ADDENDUM NO. 2, dated October 26, 2026.

RE: New Scoreboards for Baseball & Softball
OWNER PROJECT NO.: 10375279/234467/2710060
AT
Verdugo Hills High School
located at 10625 Plainview Ave, Tujunga, CA 91042

The Addendum consists of **45** pages, and the attached drawings, Sheet No. A-101, S-1.1, E-1, E-2, E-3 and E-4 with the revised date of October 26, 2026.

ELEVATION - SCOREBOARD #2 - PC

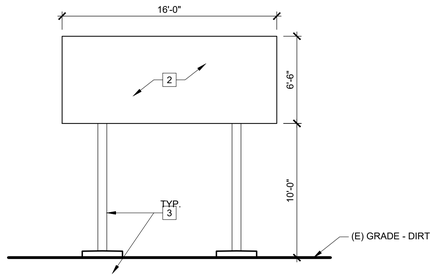
- AC thickness shown in the detail 5 changed to 3”
- Title description “PC” added to detail 4

DOCUMENT/DIVISION NUMBER: _____ DRAWING NUMBER: A-101

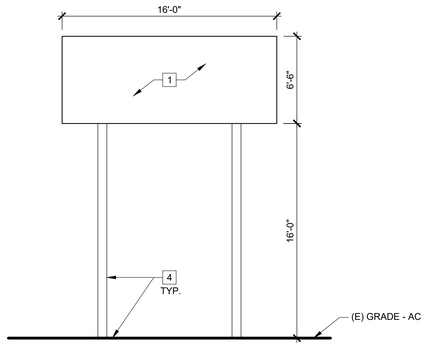
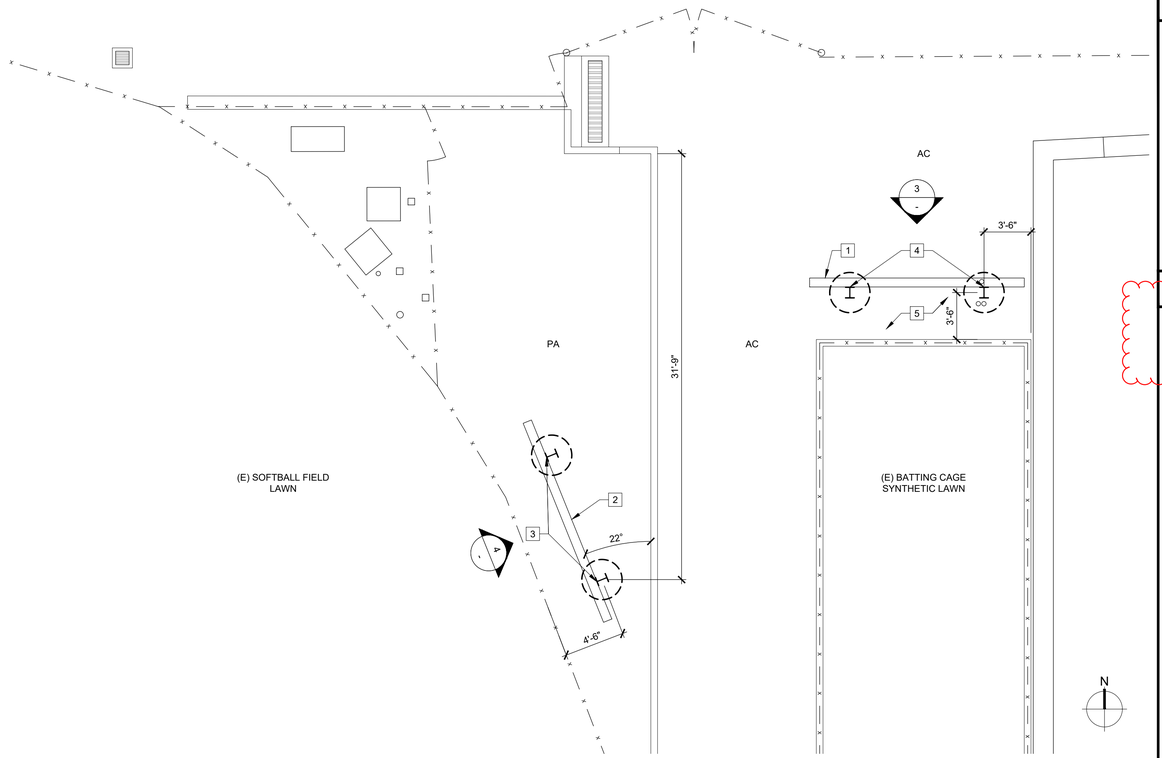
Sheet A-101 keynote #1 & #2 shows protective netting section details 3 & 4 doesn't show it. Please provide detail for netting

LAUSD Response - 10/27/2026: Please use attached details from the manufacturer.
